Subject: FW: Division of Safety of Dams (DSOD) 21 Feb 2018 presentation to the California Water Commission (CWC) meeting
Attachments: LosVaquerosInundationMap.pdf

Los Vaqueros
Reservoir Expansion Project

Flood Arrival Times for Hypothetical
Dam Break with Expansion
of Los Vaqueros Reservoir

**FIGURE
3-7**

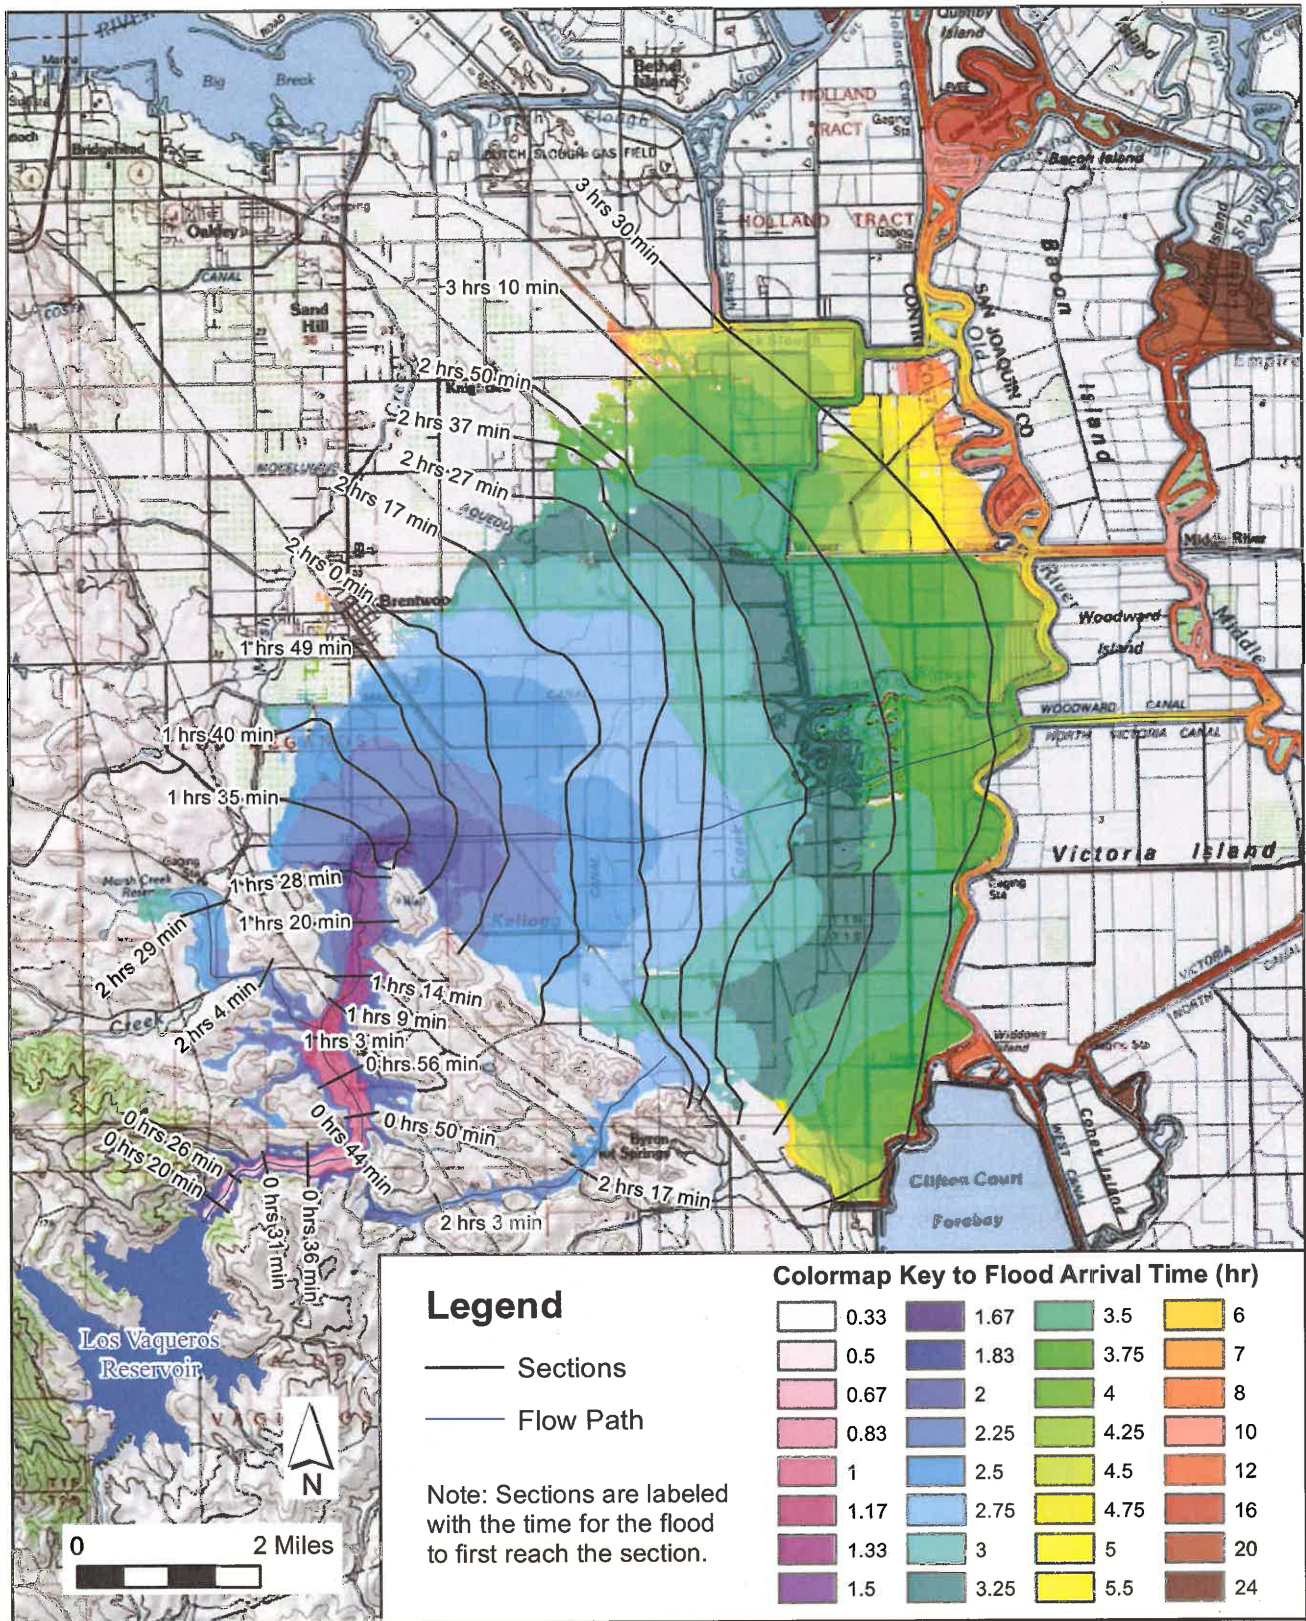
I downloaded the attached Los Vaqueros Inundation Map PDF from your web site. As I understand the process the map is approved before it is published on the web site. The drawing is missing PE stamps from Marguerite, Jerry, Ernie and John. The drawing title "Maximum Depth of Inundation for Proposed Expansion of Los Vaqueros Reservoir" is vague and probably should read 160,000 acre-feet (AF) if it is suppose to reflect what is presently built. I think for planning purposes the drawing submitted should be for the worst case scenario. I read in Reclamation's recently released feasibility report the worst case for Los Vaqueros would be 500,000. AF They wrote that would be expensive to build because it would require removing the current dam however that is the worst case and I think 500,000 AF should be published as the inundation map so city and county planners can get out in front of the flood wave as they approve new housing developments and infrastructure in the area.
